# UNITED STATES PATENT AND TRADEMARK OFFICE

APPLICATION NO.	FILING DATE	FIRST NAMED INVENTOR	ATTORNEY DOCKET NO.	CONFIRMATION NO.
09/989,369	11/19/2001	Gregory Alan Whitlow	10541-273	1119
29074	7590	08/30/2004	EXAMINER	
VISTEON C/O BRINKS HOFER GILSON & LIONE PO BOX 10395 CHICAGO, IL 60610			FORD, JOHN K	
			ART UNIT	PAPER NUMBER
			3753

Office Action Summary	Application No. 09/989,369	Applicant(s) WHITLOW ET AL. 	
	Examiner John K. Ford	Art Unit 3753

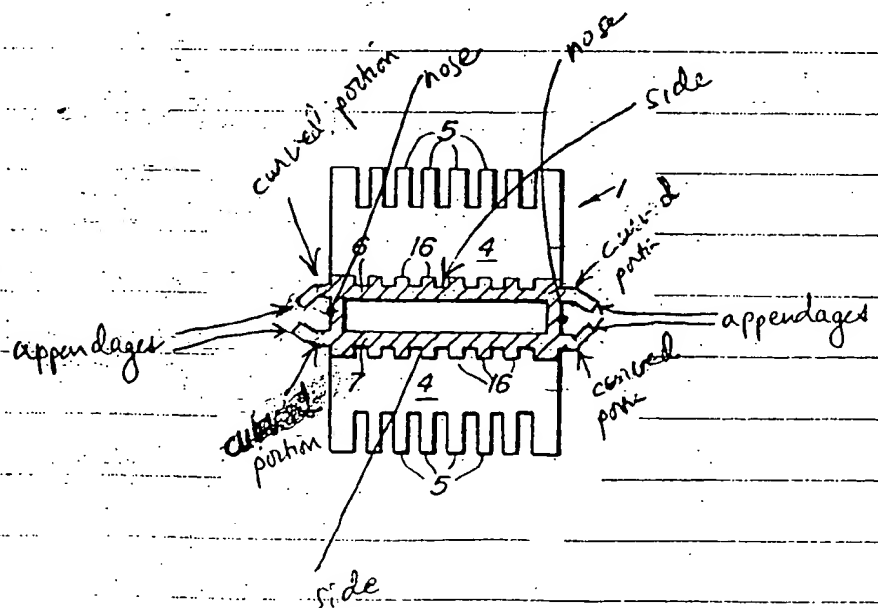
O'Connor shows straight "appendages" at each end of the tube which project outwardly parallel to major cross-section axis of the tube. To have curved each of these projections in O'Connor towards one another as taught by Yoshii Figure 1 at "4f" would have been obvious to improve air flow as discussed in col. 5, lines 5-10, by making the transition less abrupt than a blunt end would be. Such an improved curving of airflow would advantageously reduce the airside pressure drop through the heat exchanger.

The modification is shown below

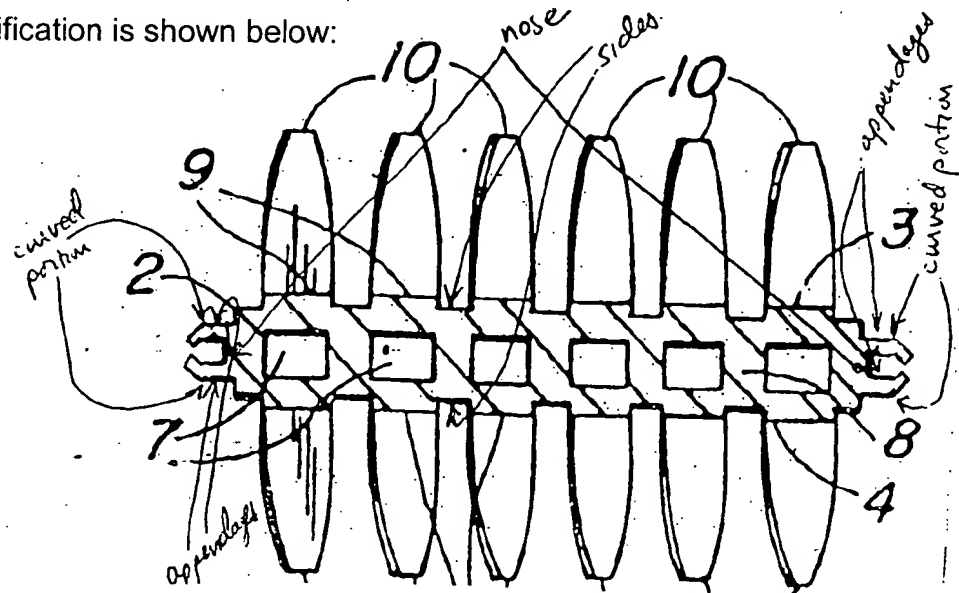
DT'069 shows straight "appendages" at each<sup>end</sup> of the tube which project outwardly parallel to major cross-sectional axis of the tube. To have curved each of these projections in DT'069 towards one another as taught by Yoshii Figure 1 at "4f" would have been obvious to improve air flow as discussed in col. 5, lines 5-10, by making the transition less abrupt than a blunt end would be. Such an improved curving of the

airflow would advantageously reduce the air-side pressure drop through the heat exchanger. The modification is shown below:
